N-series Intel[®] Pentium[®] Processors and Intel[®] Celeron[®] Processors

Specification Update

May 2018

Revision 015

ILB_BASE_ADDRESS Reference: [B:0, D:31, F:0] + 50h

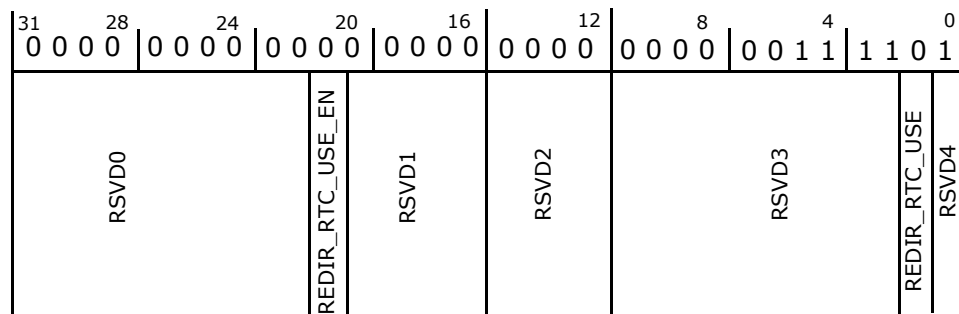
The following register is added to section 33.18 of Datasheet Volume 3. It contains the registers used in the RTC workaround in erratum CHP49.

Bit Range	Default and Access	Field Name (ID): Description
31:22	0x0 RO	RSVD0
21	0x0 RW	REDIR_RTC_USE_EN : Redirect RTC Usage Enable: When this bit is set to 0, RTCC[1] can be used to redirect RTC usage to RTC circuits not affected by erratum CHP49
20:16	0x0 RW	RSVD1
15:12	0x0 RO	RSVD2
11:2	0xF RW	RSVD3
1	0x0 RW	REDIR_RTC_USE : Redirect RTC Usage: When this bit is set to 1, RTC usage is redirected to RTC circuits not affected by erratum CHP49
0	0x1 RW	RSVD4

RCOMP Value Register

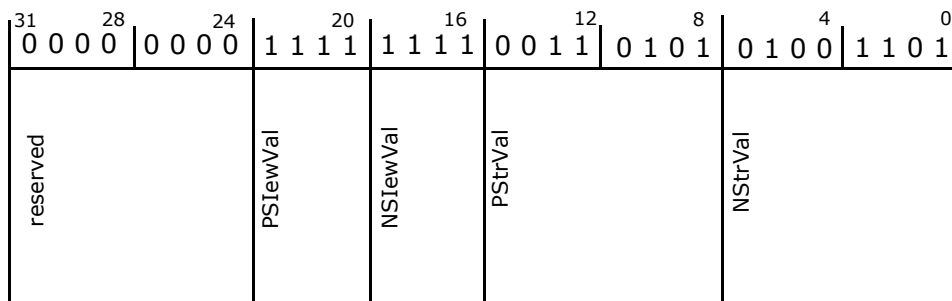
This section provides additional notes to describe the bit range of `PSIewVal` and `NSIewVal` in section 33.7.66 RCOMP Value Register (`hshvfamily_3x3_rcomp_9_0_family_rcomp_value_reg`) - **Offset 120Ch**

GPIO Family RCOMP Register

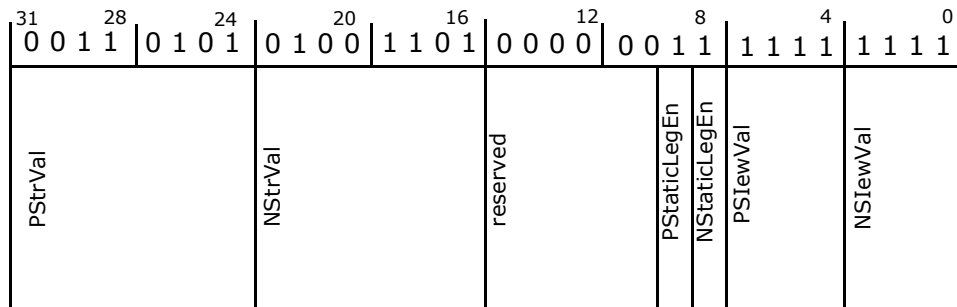
This section provides additional notes to describe the bit range of PSIewVal and NSIewVal in section 33.7.67 Family_config_rcomp_reg (hshvfamily_3x3_rcomp_9_0_family_rcomp_value_reg) – **Offset 1210h**

RCOMP Value Register**Access Method**

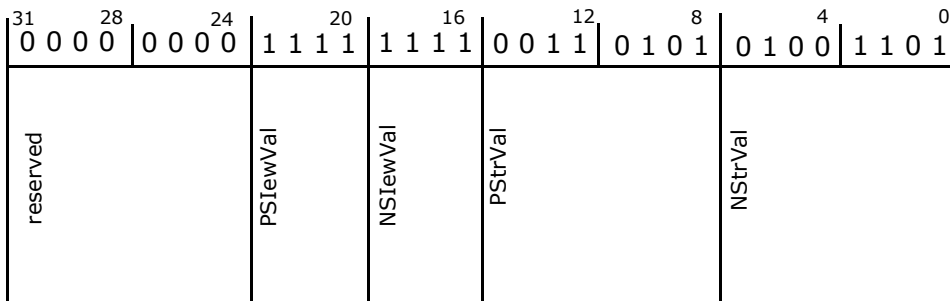
This section provides additional notes to describe the bit range of PSIewVal and NSIewVal in section 33.7.60 RCOMP Value Register (hshvfamily_2x3_rcomp_7_0_family_rcomp_value_reg) – **Offset 118Ch**
